Technical Note

CLIENT:	Extra MSA
PROJECT:	Proposed Erection of a Motorway Service Area, Land to the North of Junction 11 of the M62, Warrington
SUBJECT:	Groundwater Technical Note in response to EA letter dated 14 Feb 2020 SO/2019/119672/03-L01
JOB NO.:	SH11739
DATE:	20 March 2020
PREPARED BY:	L Ballarini: Service Area Lead – hydrogeology and hydrology

Figure 1: Groundwater monitoring levels for the Sherwood Sandstone (Risley Landfill HRA dated February 2017)

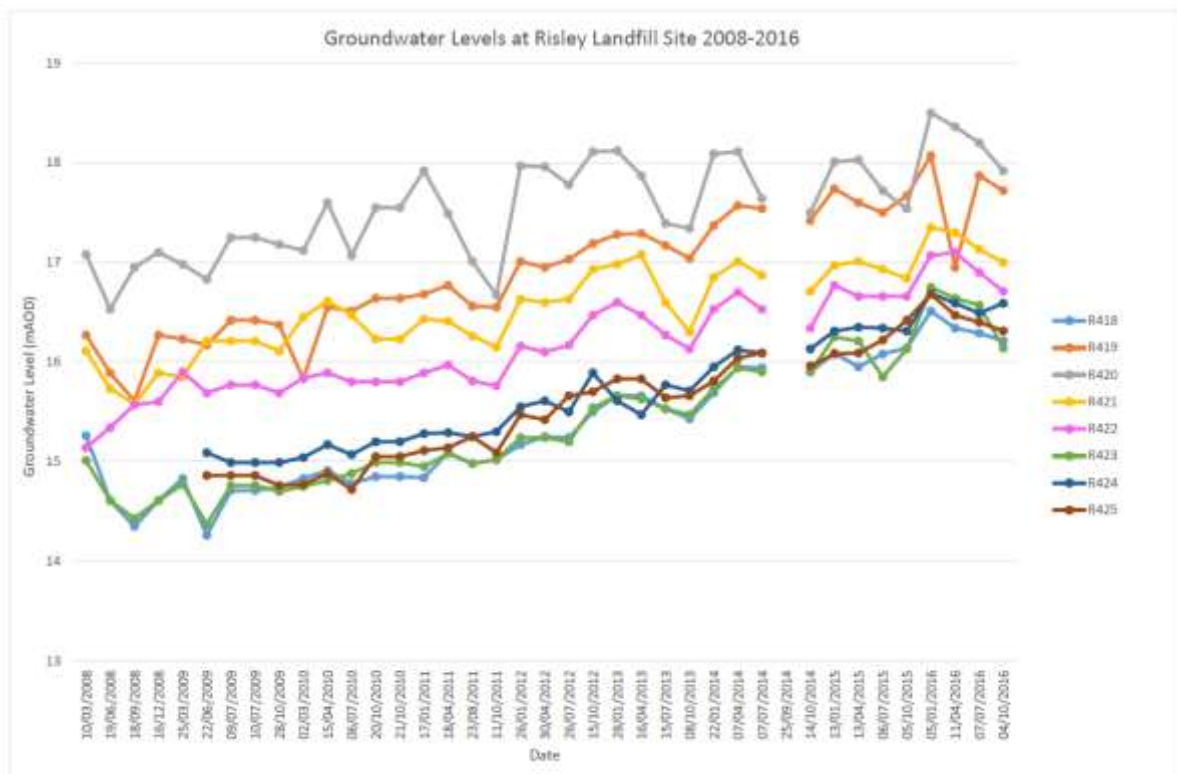
EA comment: The closest borehole to site is R421 which exhibited a maximum groundwater level of 17.35m above ordnance datum (AOD). The elevation at this point is 22.18mAOD in line with this data and as such the groundwater level is expected to be at 4.83m below ground level (bgl).

Clarification is required as to whether this data is a long term maximum, as we know that groundwater levels in this area are heavily influenced by public water supply abstractions. These were unused for a number of years and groundwater rose to a maximum level in around 2012. We require confidence that the tanks would not become sub water table if the pumps were switched off again and the groundwater regime returned to a more natural state.

WA response: Borehole R421 is installed within the Sherwood Sandstone based on the information provided in the Hydrogeological Risk Assessment (HRA) for the neighbouring Risley Landfill site (DWG No: BF4946/5/HRA1 titled 'Conceptual Model' dated Feb 2017). No borehole logs are available for this borehole however based on the conceptualisation presented in the Hydrogeological Risk Assessment (HRA) for the neighbouring Risley Landfill site (DWG No: BF4946/5/HRA1 titled 'Conceptual Model' dated Feb 2017) this borehole

would appear to be overlaid by c. 9m boulder clay. The elevation of this borehole is reported to be 22.71m AOD and the maximum groundwater level recorded was 17.35m AOD (5.36m bgl). This is the maximum level recorded between March 2008 and October 2016 based on data provided by Biffa in their HRA and re-presented in Figure 1.

DRAWING TITLE
Groundwater Monitoring Locations

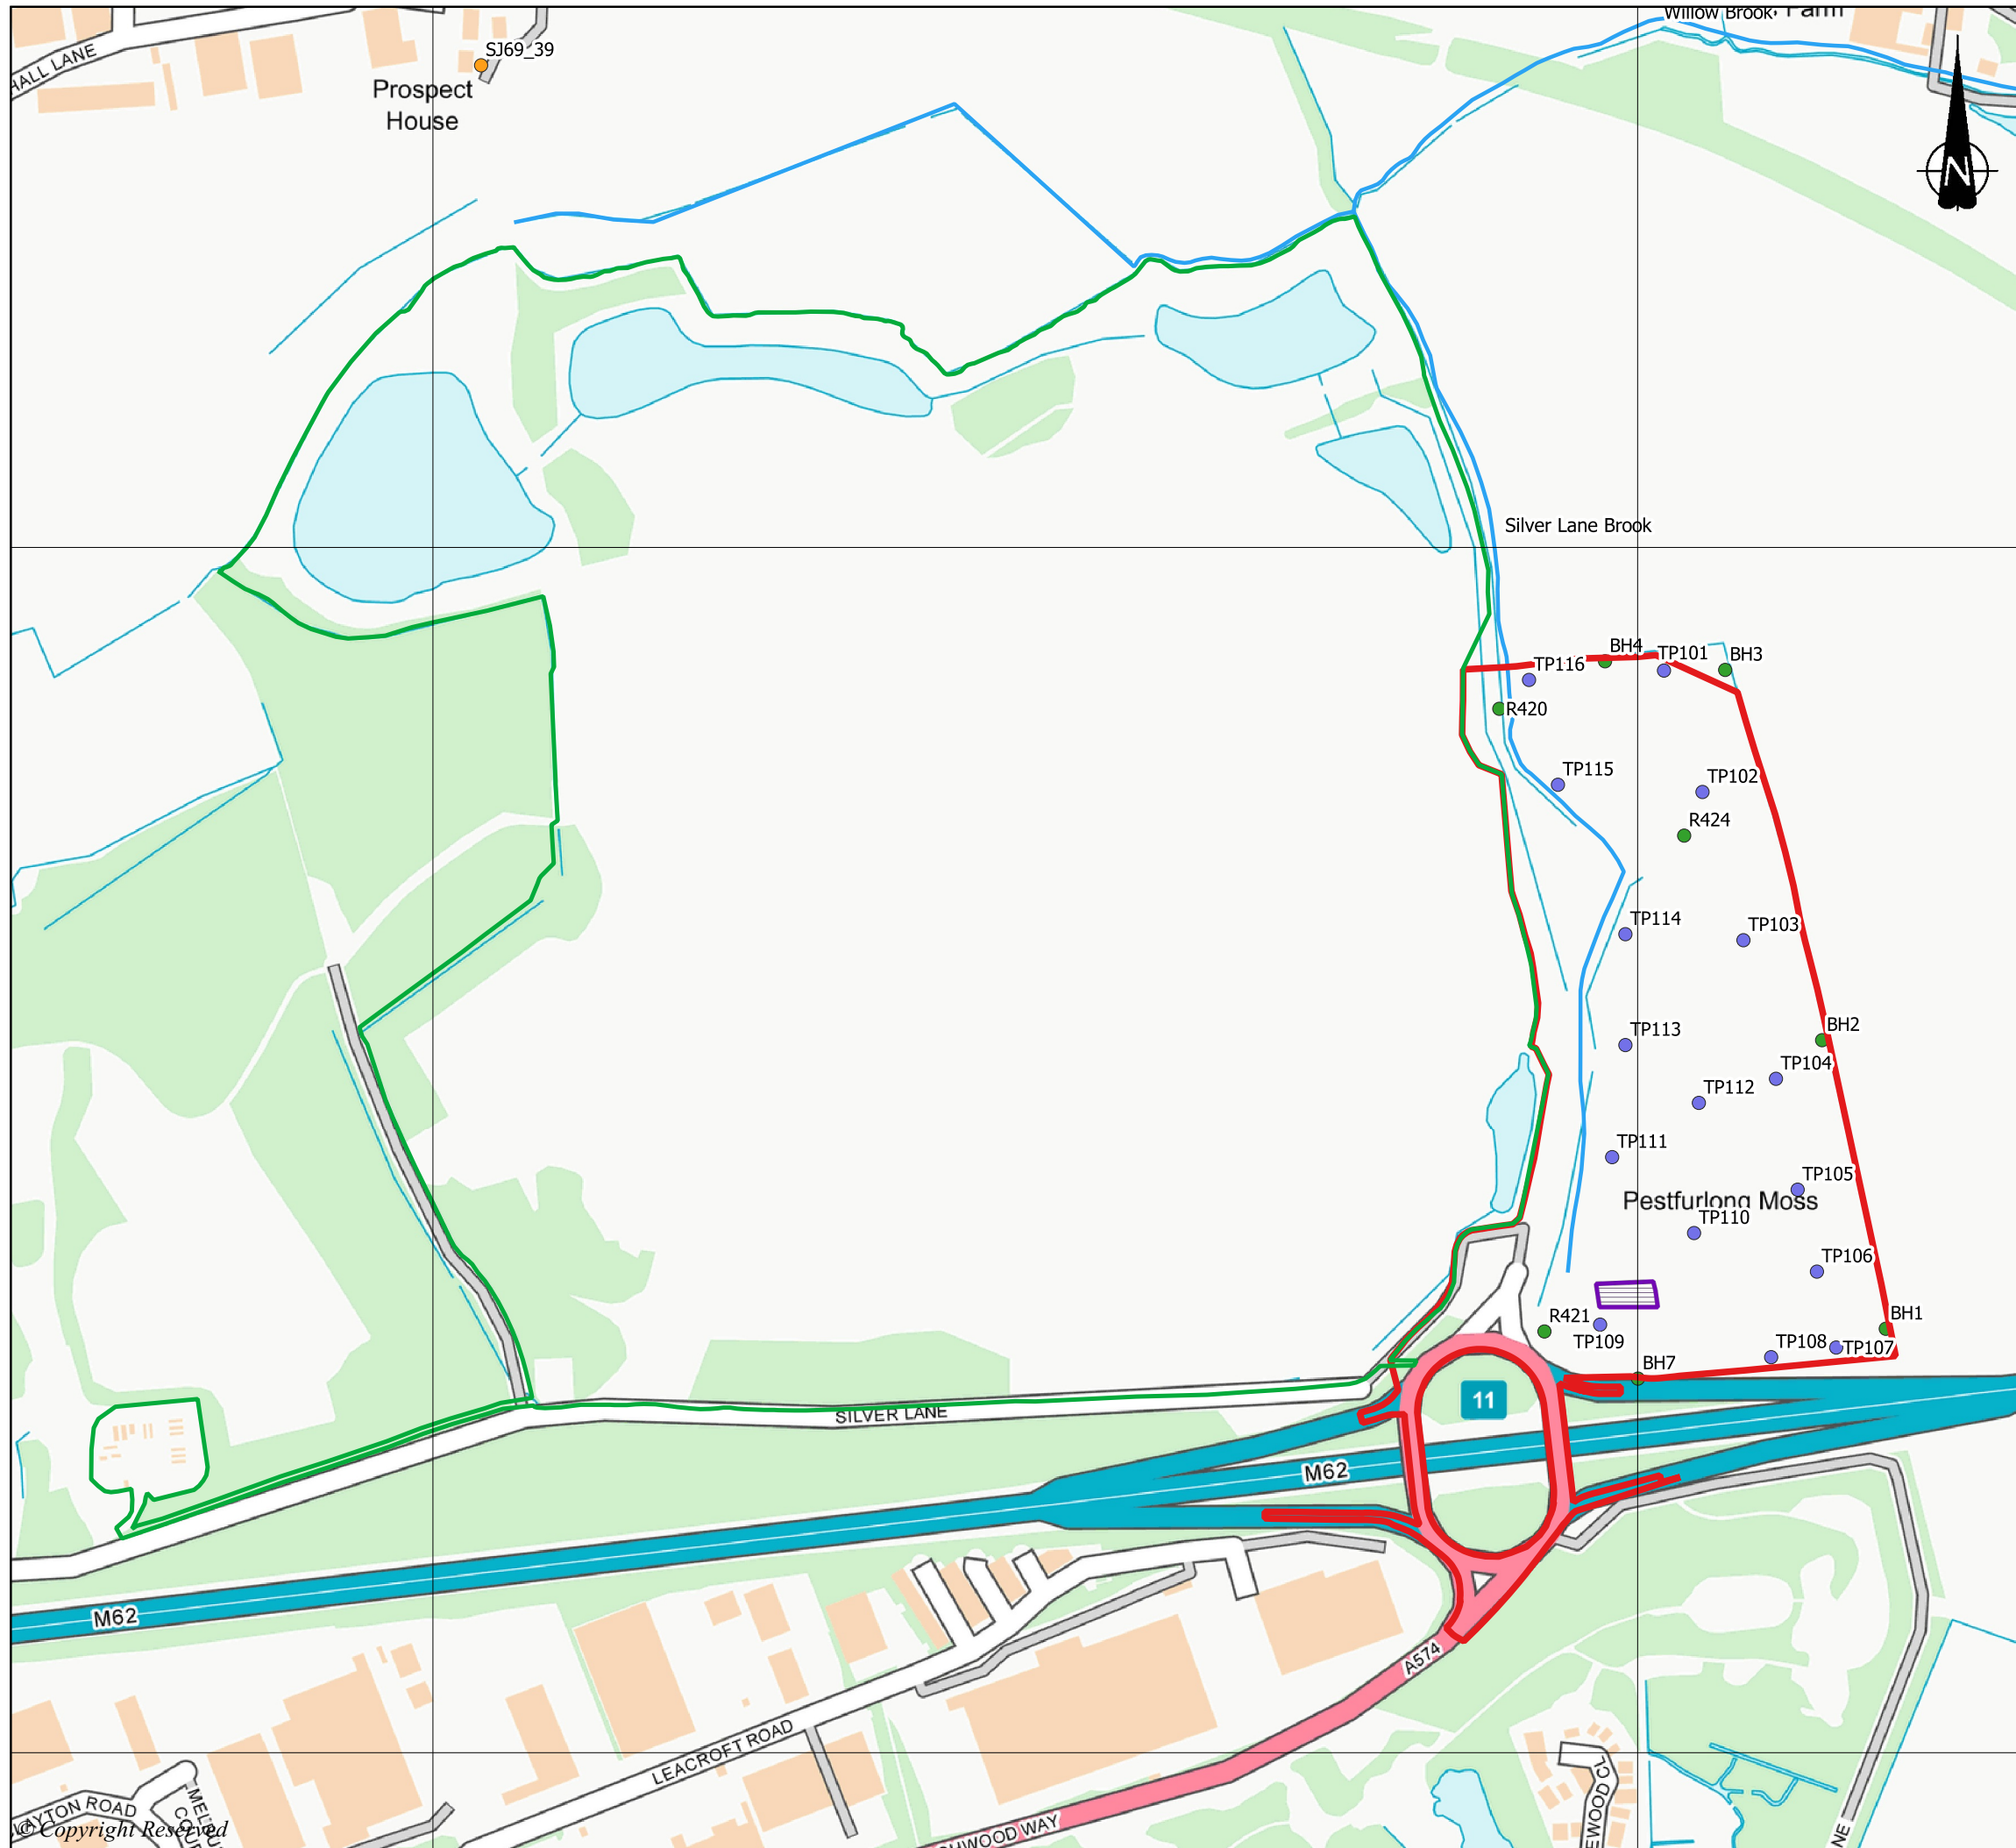
EA comment: The landfill monitoring boreholes must be preserved. Their location needs to be identified and outside the red line boundary.

A location plan showing Sherwood Sandstone groundwater monitoring boreholes referred to within the Warrington MSA Water Resources Technical Paper of the Environmental Statement Part 2 is presented as DWG No: SH11739-062 –titled ‘Groundwater Monitoring Locations’ dated February 2020 and included with this Technical Note.

WA response: As identified above, the MSA planning red line boundary does not encroach on Risley Landfill's permitted green line boundary. There are a number of groundwater and gas monitoring boreholes located around the edge of the proposed MSA. However only R420, R421 and R424 are present within the red line boundary and included within the requisite surveillance for the Risley landfill. All groundwater and gas monitoring boreholes identified as part of Risley Landfill's requisite surveillance and located around / within the proposed MSA site will be protected throughout construction, operations, and access. Access to these boreholes by Biffa to undertake their monitoring has already been agreed via a Land Control Agreement between Biffa and Extra. There is thus no requirement for the locations of these boreholes to be excluded from the redline planning boundary.

Project	Originator	Volume	Level	Type	Role	Number
RMS - 519 - ZZ - XX - DR - A - 0703						
COMBINED PARAMETER PLAN

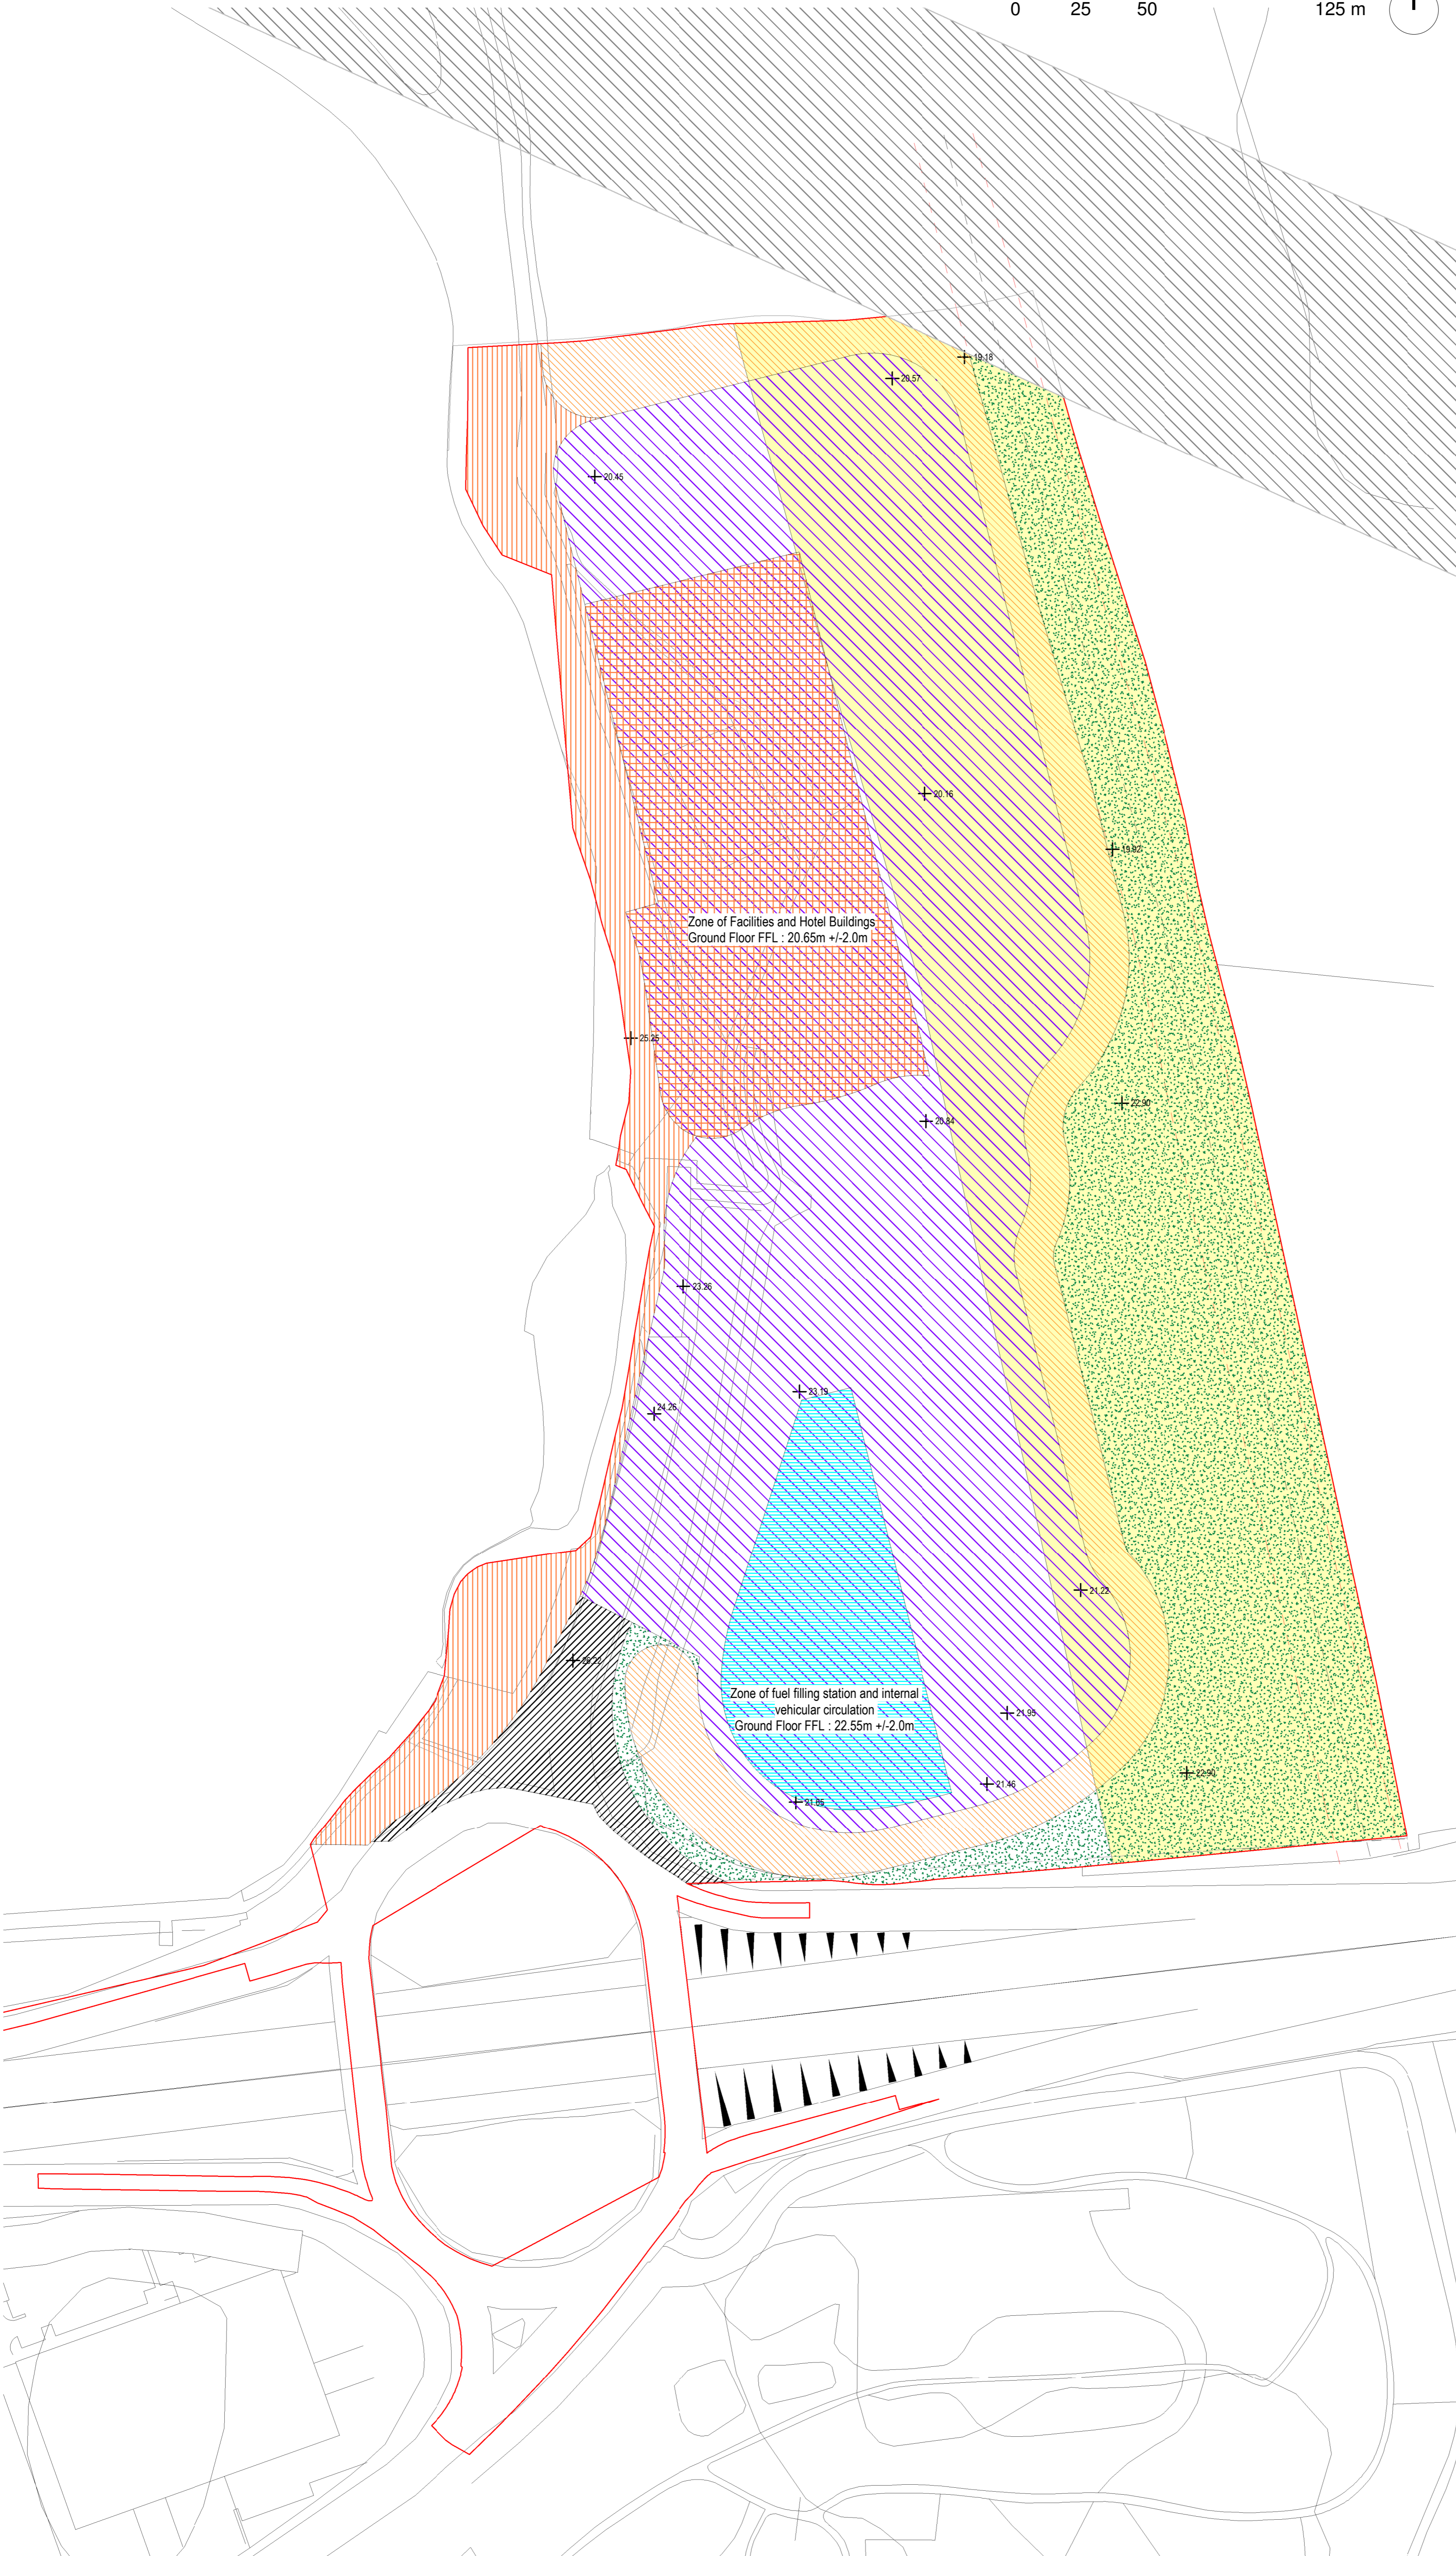
EA comment: [Provide information on] finished floor level data including expected level of brook.

In terms of finished floor levels, Architecture 519 drawing RMS-519-ZZ-XX-DR-A-0703 revision P12 titled 'Combined Parameter Plan', submitted as part of the planning application, details the general proposed site levels and finished floor levels. We also attach a new drawing, Wardell Armstrong drawing SH11739-004E titled 'Indicative Levels Design', which confirms the levels shown on the Combined Parameter Plan as well as providing additional details of the indicative levels being considered across the site and to the brook.
